# HDIce Status Report

## Detector Support Group

Monday, March 20, 2017 2

# Noise Test for Varying Frequency

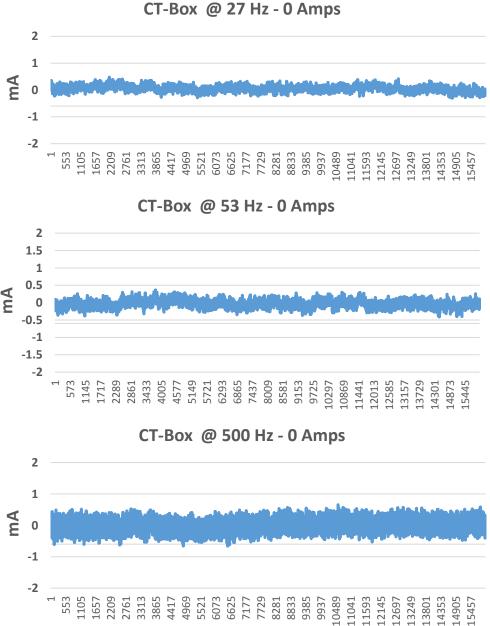
Report statement: HDIce report stated field signal noise in CT-Box enabled condition appears way too high, on order of 2 gauss.

• DSG response: CT-Box noise test conducted in control room does not show 2 gauss noise.

- Tested at 27 Hz, 53 Hz, and 500 Hz.
  - Frequency chosen due to min and max scan times.
- Signal shown to center 0 mA and not exceed 1 mA.

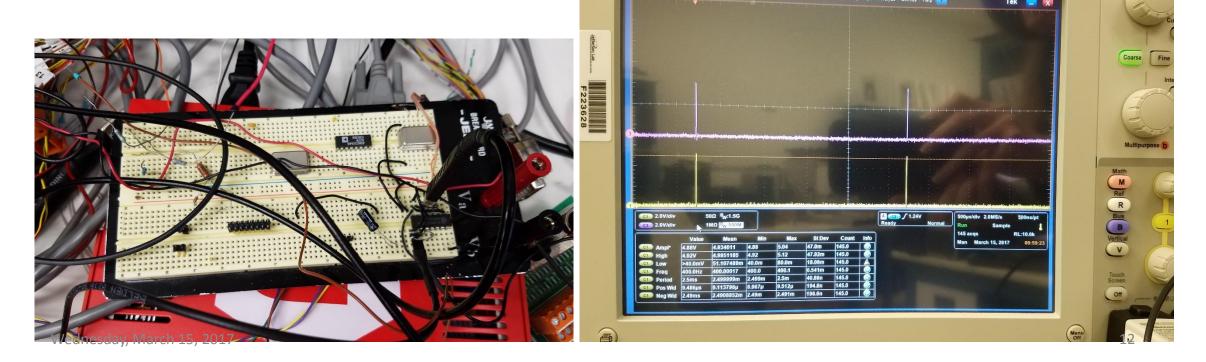
Report statement: Trigger lock-in scan and field sweep when CT-Box current crossed threshold, once for every IPS sweep.

- DSG response: CT-Box has to send trigger signal to Lock-In Amplifier for every data point required.
  - Single trigger will not work.
    - Requires instruments to use own acquisition clocks and run asynchronously.
    - o Both instruments required to have same or integral multiple of the other's frequency.
      - The lock-in amplifier fixed sample rate intervals of 64 Hz, 128 Hz, 256 Hz, and 512 Hz.
      - The CT-Box's acquisition frequency is programmable from 1 Hz to 100 KHz in 10 μs steps.
    - Misalignment between CT-Box and lock-in amplifier measurements will occur.
